**Response to RAI-11 Regarding Background Radiological Characteristics**

**Technical Memorandum**  
**Response to November 16, 2017 Public Meeting Conference Call to Discuss RAI**  
**Responses with Lost Creek ISR: RAI-11 (b, c, d)**

**December 11, 2017**

**Figure 2. Probability Plots of the 2006 and 2013 Gamma Survey Data**

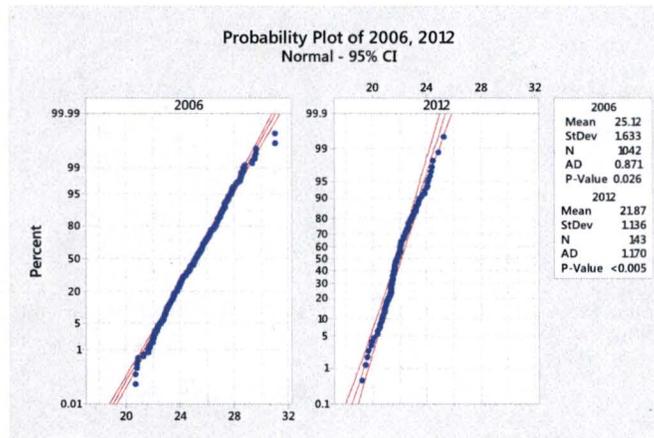
Tetra Tech's Response #2 is related to the NRC's request on Page 11 of ML17324B356 for additional information related to the calibration of the UTV-based radiation measurement instruments. RAI-11(b) *Gamma scans* specifically states: (2) *The correlation between previous UTV-based gamma scans (2008 Tech Report volume 2 section 2.9) and the 2013 UTV-based scans (2017 Tech Report section 3.12 and D-10) is not well documented.* The NRC requested Lost Creek ISR, LLC to provide additional information concerning the calibration of the UTV-based radiation measurement instruments used for exposure rate measurements. The request also notes that characterization of background radioactivity levels is needed for several radionuclides in addition to radium-226.

Tetra Tech concluded in Section 5.0 of the 2013 Baseline Study Report that the difference between the average of measurements (2006 and 2012) was 13.8%. Therefore, the gamma exposure rates were corrected by this normalization factor to allow direct comparison of the data sets. The purpose of normalizing the data in this way is to allow use of the 2006 HPIC and gamma-soil-radium correlations, which could then be applied site wide to meet the objectives of the scope of work. An analysis was performed to show the distribution of 2006 vs. 2012 gamma measurements. Figures 2 and 3 present the normal probability and frequency histograms comparing the two surveys.

**Figure 5. LCE Gamma Exposure Rates (2012 Scan Results)**

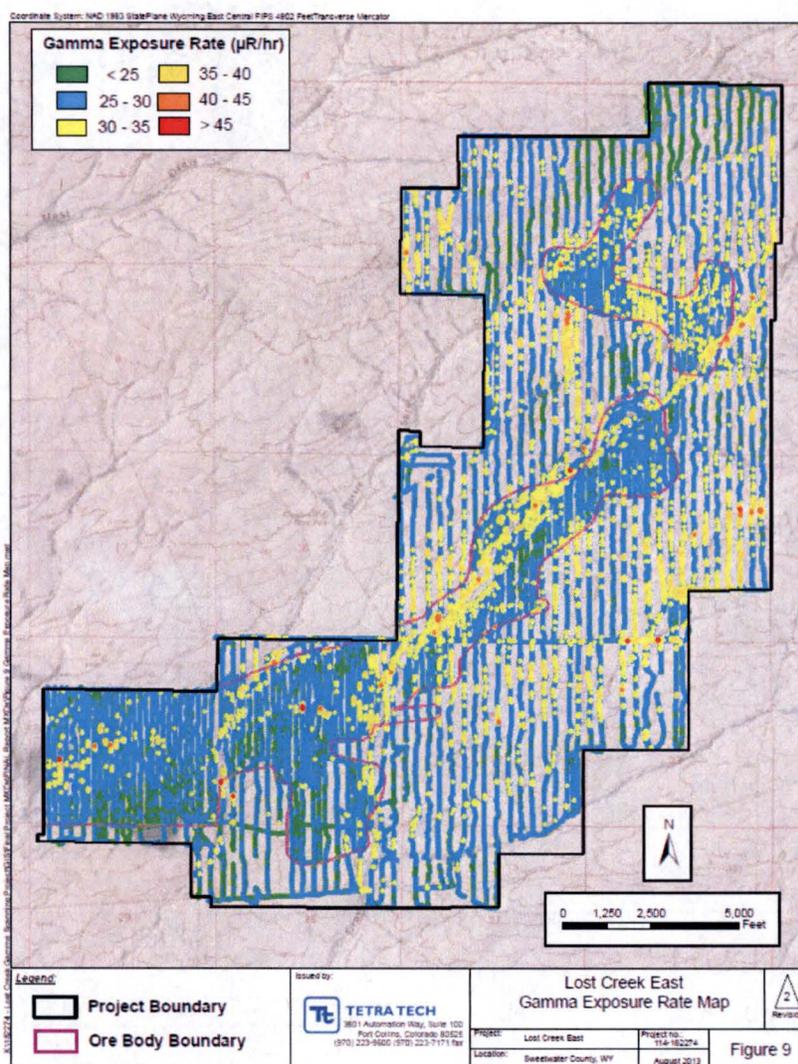
The NRC stated that data gaps were present in the LC East (LCE) information concerning preoperational monitoring. Discussion during the November 16, 2017 conference call provided additional detail concerning the NRC observation. NRC staff noted that, while the original Lost Creek report (2006) provided data for a set of soil samples complying (as feasible) with NRC Regulatory Guide (RG) 4.14 (1980), the LCE data (2012) listed samples taken only at the air monitoring station locations. The NRC requested that additional soil samples be taken over the LCE area, using a system and number of samples to be proposed by Lost Creek/Tetra Tech staff.

Because the LCE expansion area will contain no facility corresponding to a “mill” (liquids extracted from the LCE area will be processed at the facility located in the original LC area), the RG 4.14 guidance cannot be applied to the LCE area. Therefore, to develop the requested additional soil sampling regime, we propose instead to utilize the 2013 report’s LCE gamma scanning data set to identify locations of interest for soil sampling. This approach focuses sampling on areas that indicate the presence of naturally occurring radioactive material. Data from such locations may prove to be of value in later years, during site closure operations. Figure 5 presents the raw gamma exposure rate data from the 2013 LCE report. Figure 6 presents the proposed soil sampling locations.
